# Economic and Social Council

### Working Party on Noise

Sixty-ninth session

## Report of the Working Party on Noise on its sixty-ninth session

“Figure 4

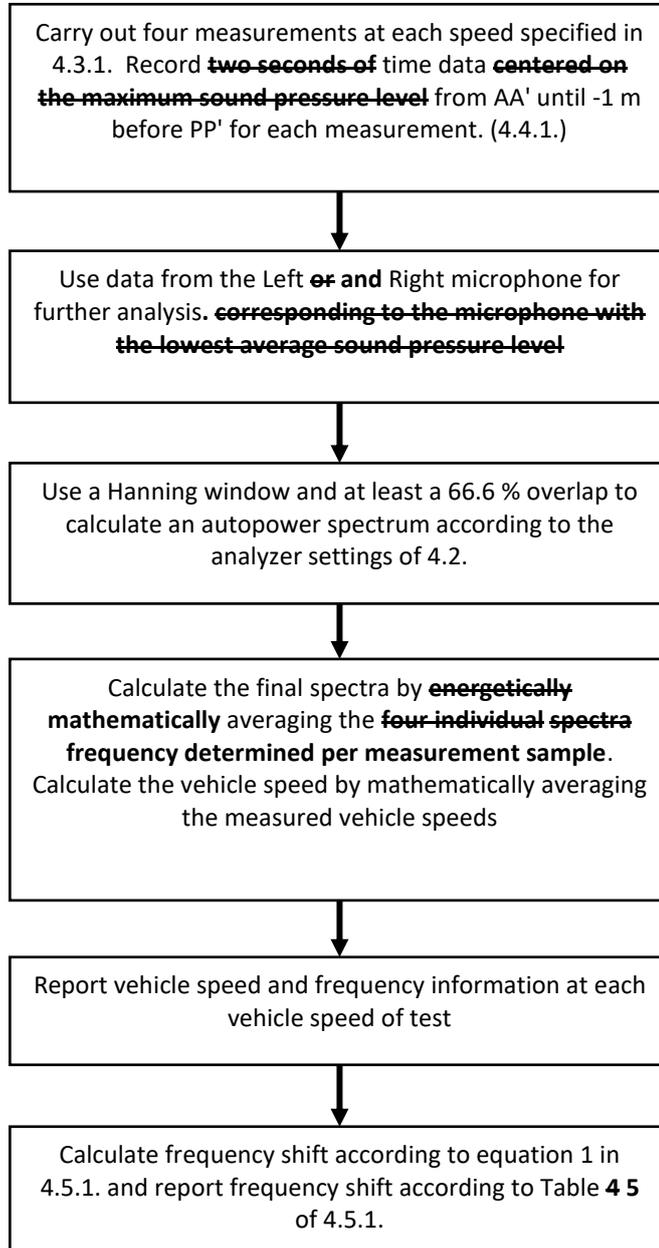
Appendix to Annex 3 Figure 4, amend to read:

~~Determination of the range of background noise~~ **Background Noise Parameter”**

“Figure 7c

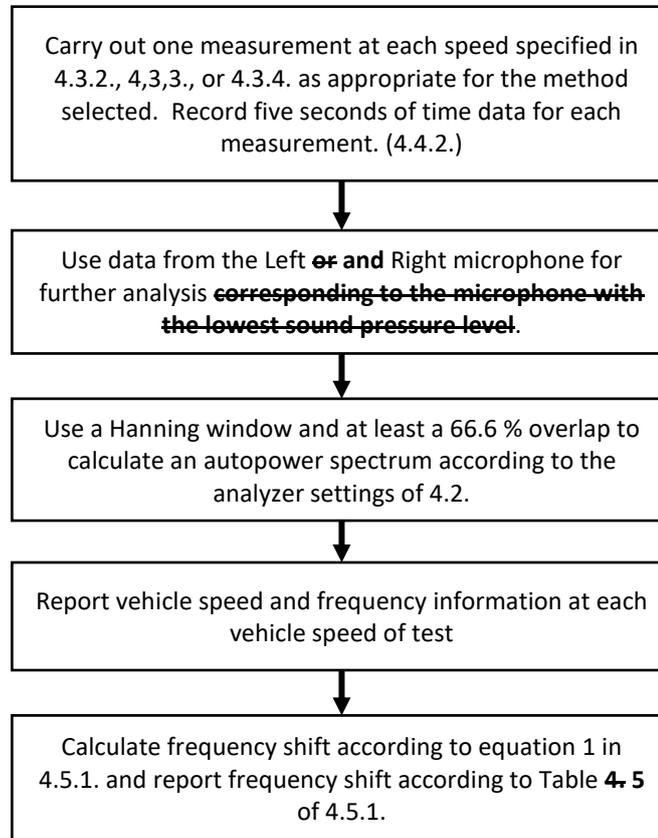
Appendix to Annex 3, Figure 7c, amend to read:

Test procedures for measurement of frequency shift, Methods B, C, D, and E
